Stage 1 Road Safety Audit – Designers Response

Land south of Furners Lane,
Henfield,
West Sussex

Stage 1 Road Safety Audit

Report No. EC/2024/09/GTA2

Access Plan

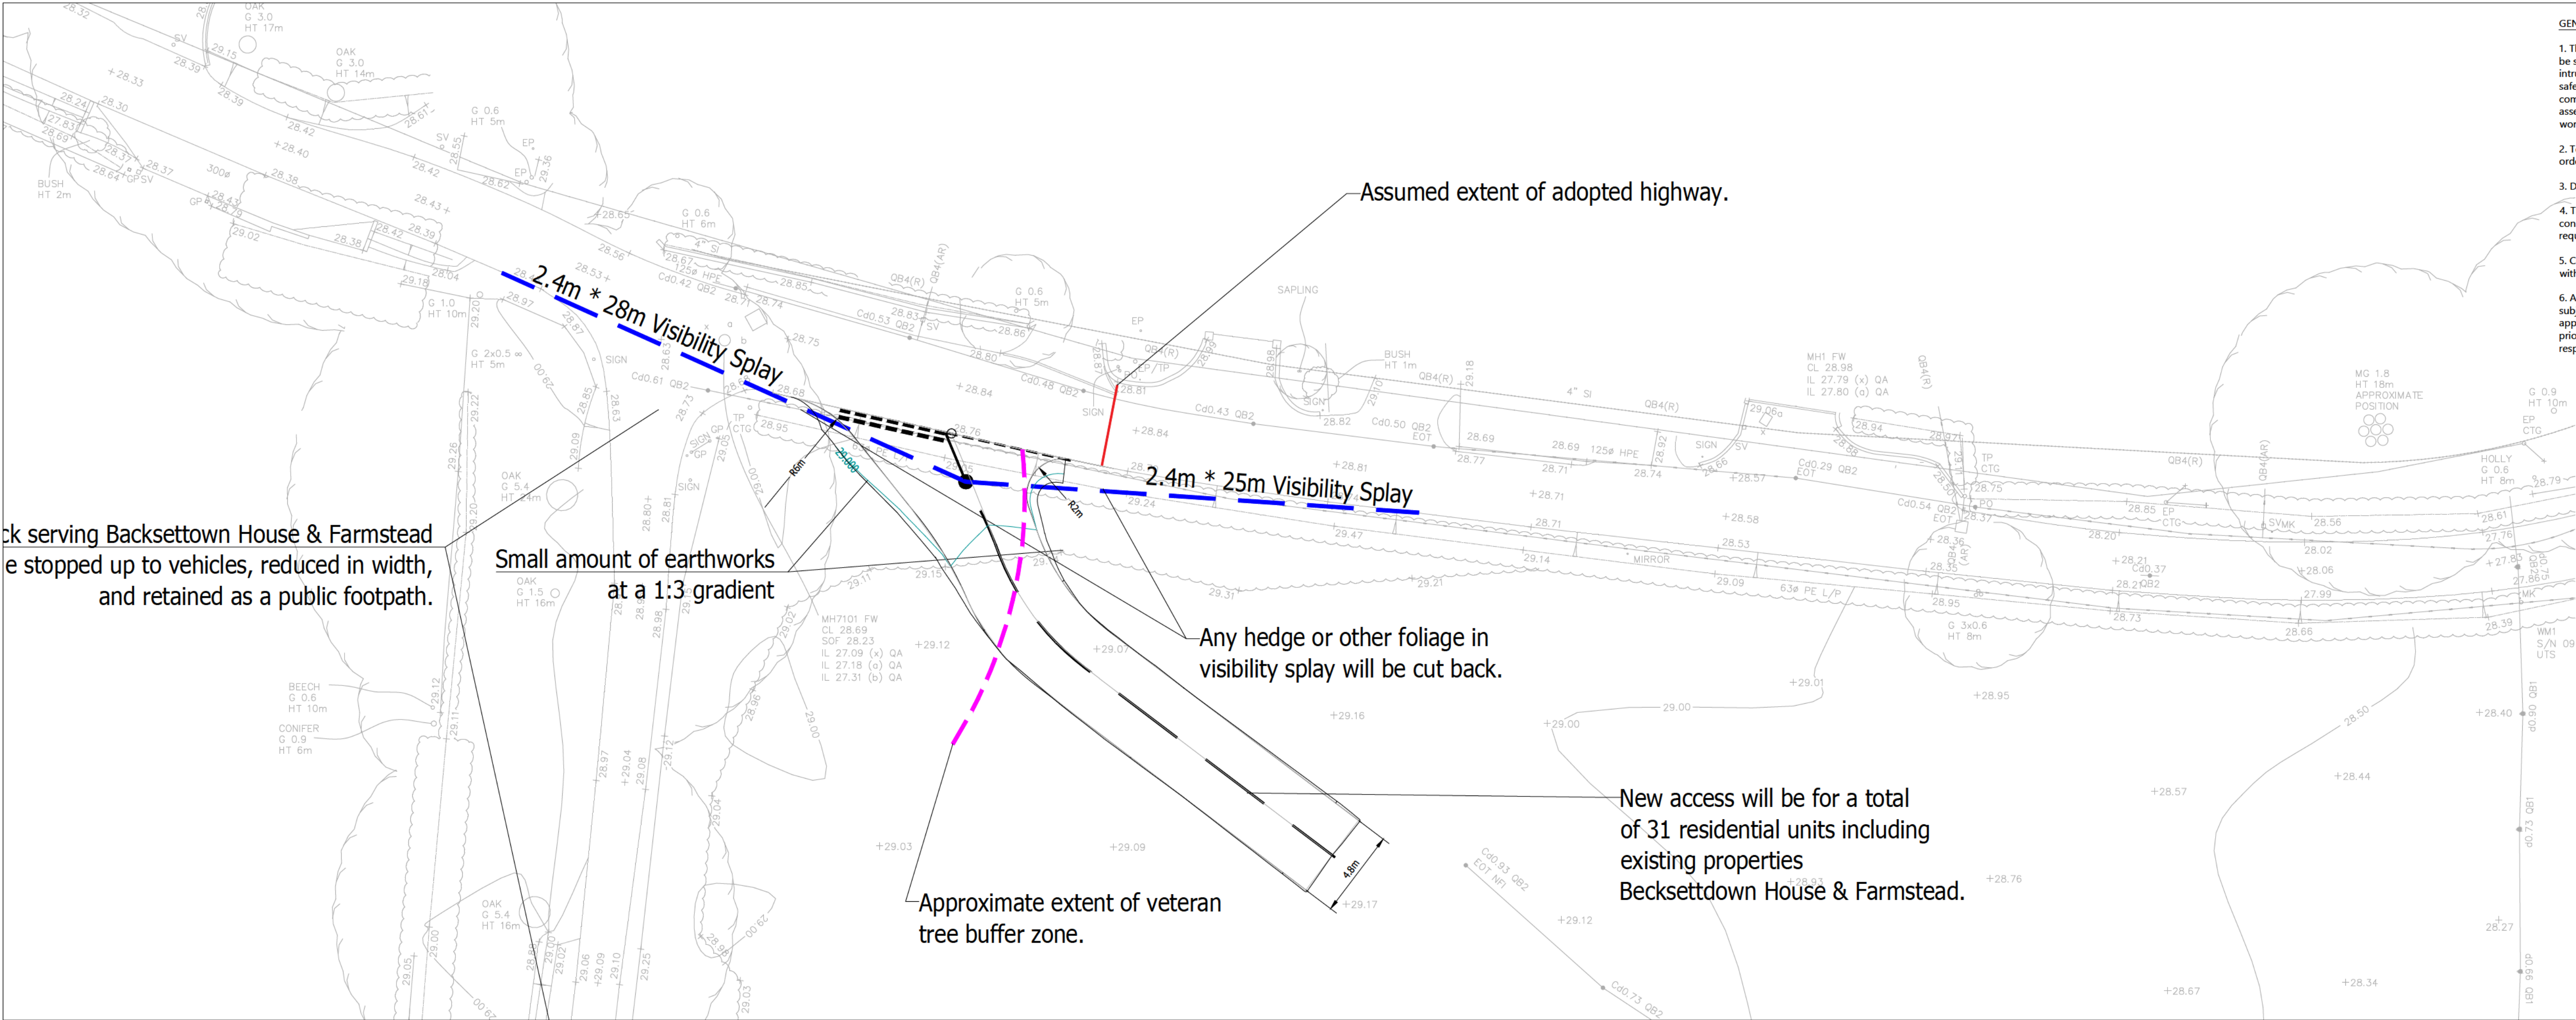
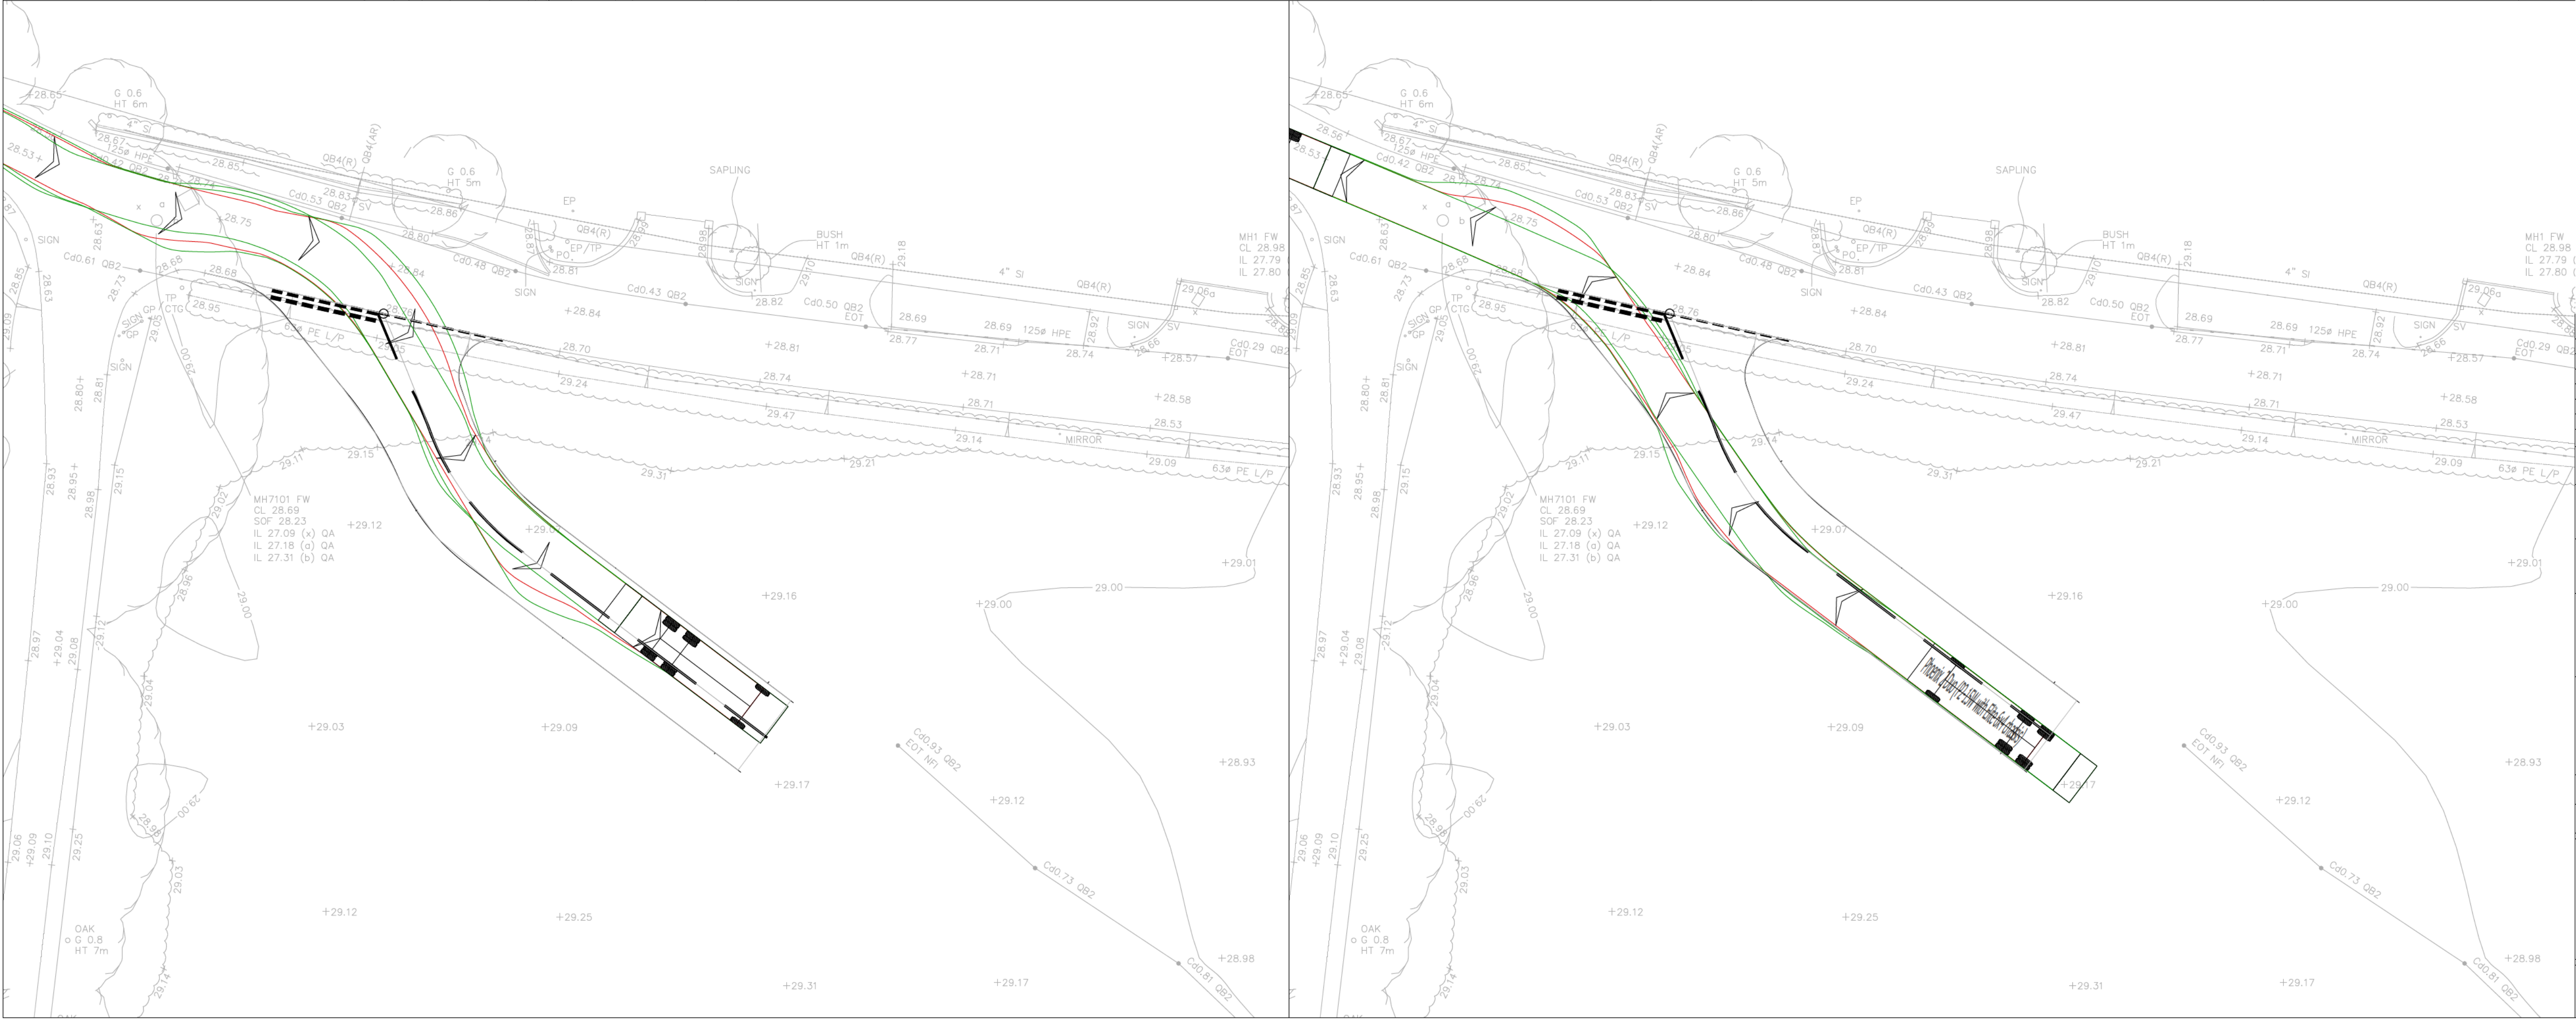
Detail: The drawing states that refuse vehicles will not be able to turn right from the access onto Furners Lane. Although the refuse collection authority may agree to their vehicles only turning left out of the access, drivers of other large vehicles may wish to turn right onto Furners Lane. In order to achieve this manoeuvre, they may pull out of the access towards the other side of the carriageway and reverse back to achieve the turn. This three-point manoeuvre will increase the risk of reversing related collisions involving vehicles or pedestrians crossing the access behind any manoeuvring HGV.

It is recommended that the design be modified to allow large vehicles to turn right out the access. Swept path analysis should be undertaken to demonstrate that the right turn out of the site access can be safely made by all large vehicles likely to access the site.

Detail: It was noted on site that several vehicles currently park directly opposite the proposed access. Such vehicles are likely to restrict turning movements for vehicles accessing site, particularly larger vehicles. The parked vehicles could also interfere with the free flow of traffic increasing the risk of vehicle to vehicle collisions.

It is recommended that measures are introduced to manage on street parking at the location. Measures may include, but are not limited to, 'At any time waiting' restrictions (double yellow lines).

Problem	Location	Description	Recommendation	Design Organisation Response	Overseeing Organisation Response	Agreed RSA Action
4.1	Proposed Access	Risk of large vehicle collisions relating to reversing manoeuvres at the access – The drawing states that refuse vehicles will not be able to turn right from the access onto Furners Lane. Although the refuse collection authority may agree to their vehicles only turning left out of the access, drivers of other large vehicles may wish to turn right onto Furners Lane. In order to achieve this manoeuvre, they may pull out of the access towards the other side of the carriageway and reverse back to achieve the turn. This three-point manoeuvre will increase the risk of reversing related collisions involving vehicles or pedestrians crossing the access behind any manoeuvring HGV.	It is recommended that the design be modified to allow large vehicles to turn right out the access. Swept path analysis should be undertaken to demonstrate that the right turn out of the site access can be safely made by all large vehicles likely to access the site.	Not agreed. The access has been designed for all vehicles to turn right in / left out as the lane to the east only serves farms and a few private dwellings. Therefore, this movement will not be needed. If vehicles need to access further east of Furners Lane, it is likely that they will be travelling in that direction along Furners Lane as existing and will not be entering the proposed development.	LHA agree with Designer considered unlikely that vehicles would be turning east out of development The access has been designed to discourage large vehicles turning right out of the development on to what is unadopted highway	no further action

4.1.2	Proposed Access	Parked vehicles increase the risk of vehicle-to-vehicle collisions – It was noted on site that several vehicles currently park directly opposite the proposed access. Such vehicles are likely to restrict turning movements for vehicles accessing site, particularly larger vehicles. The parked vehicles could also interfere with the free flow of traffic increasing the risk of vehicle-to-vehicle collisions.	It is recommended that measures are introduced to manage on street parking at the location. Measures may include, but are not limited to, 'At any time waiting' restrictions (double yellow lines).	Not agreed. The parking on street along Furners Lane is intermittent and irregular, with parked cars not constantly obstructing access. Therefore, it is not considered necessary to introduce any parking restrictions. This matter can be considered at the detailed design stage and discussed with WSCC.	The plan has been updated to include 2 x visitor spaces along site access road to provide parking for displaced vehicles on Furners Lane. The auditor has revisited this point and reviewed tracking and considers this point now addressed	no further action

However, to address the concern, I note the added addition of visitor parking spaces for any displaced parking. Thank you or also sending through the additional vehicle tracking (Drawing Number 1207_100) which shows the turning movements of vehicles from the access, and this does show such turns into and out of the site would have limited impact, even with the parked vehicles in Furners Lane.

LOCATION OF PROBLEMS PLAN

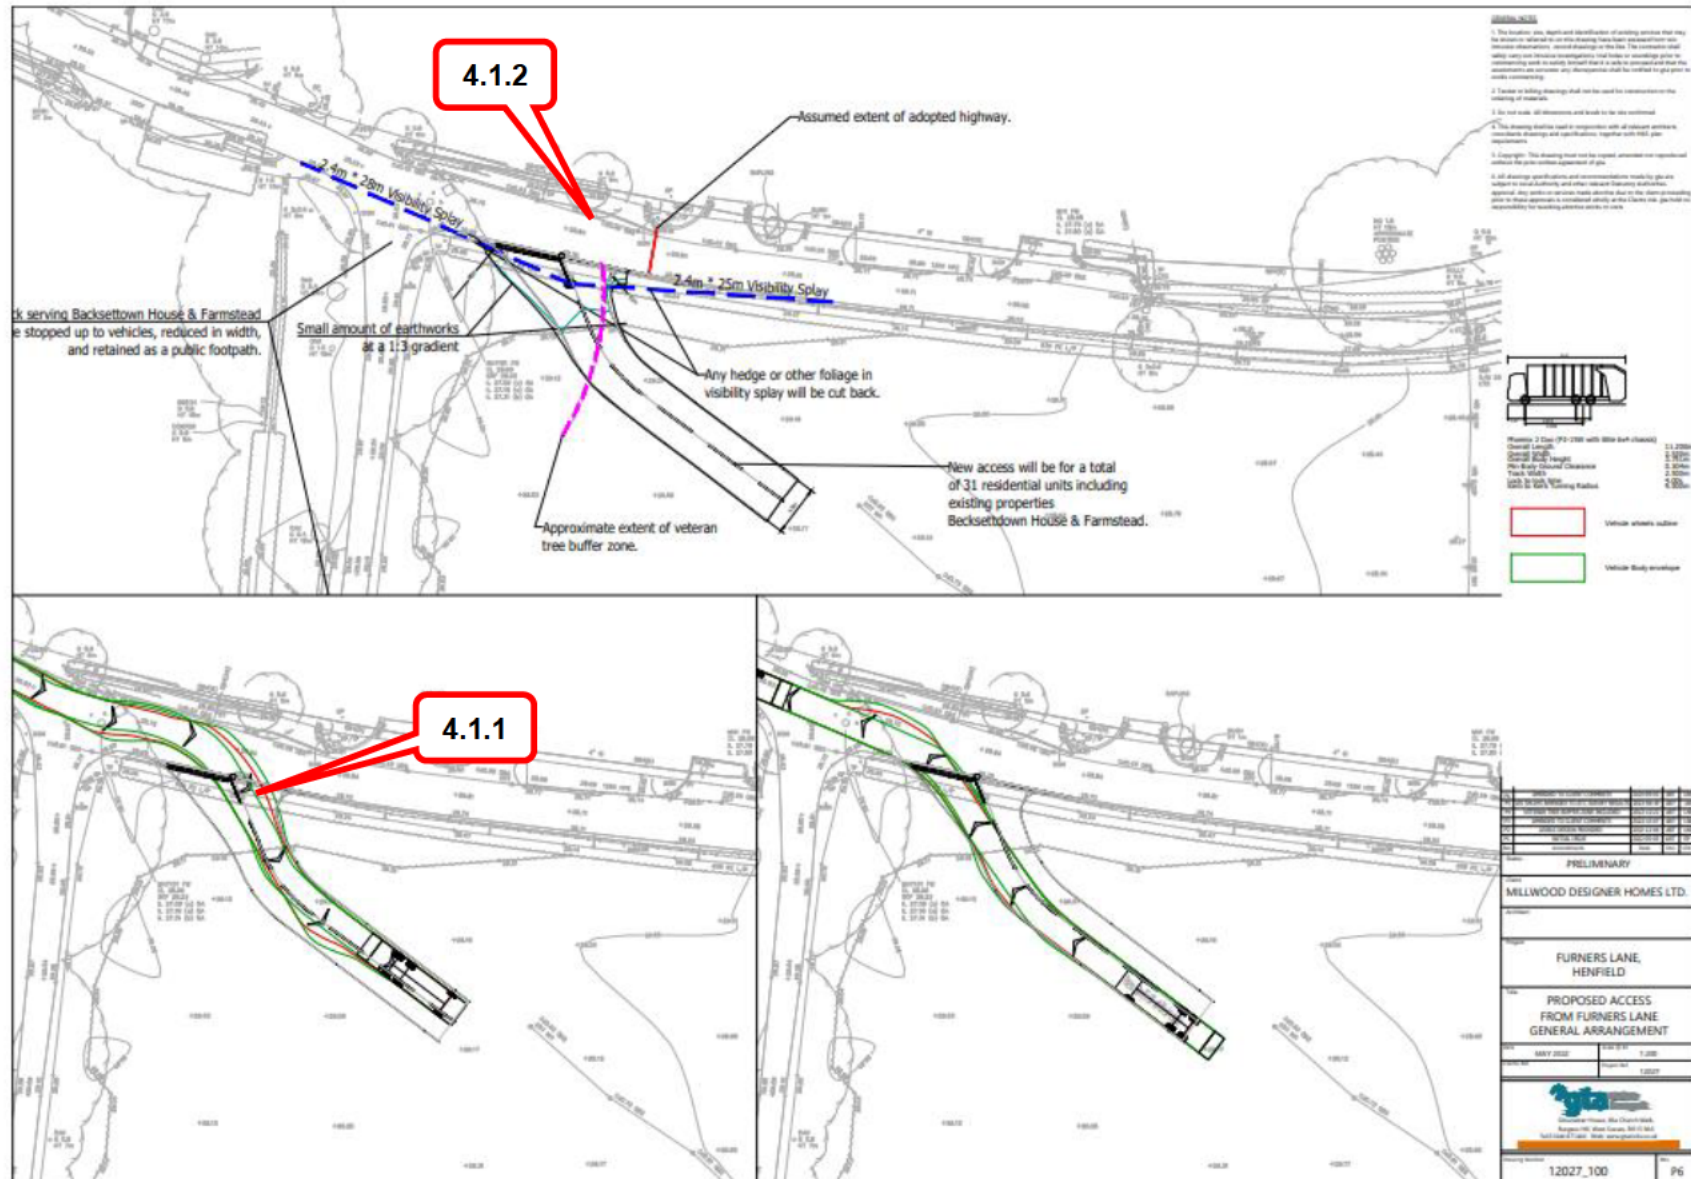
Summary: Risk of large vehicle collisions relating to reversing manoeuvres at the access.

Summary: Parked vehicles increase the risk of vehicle to vehicle collisions.
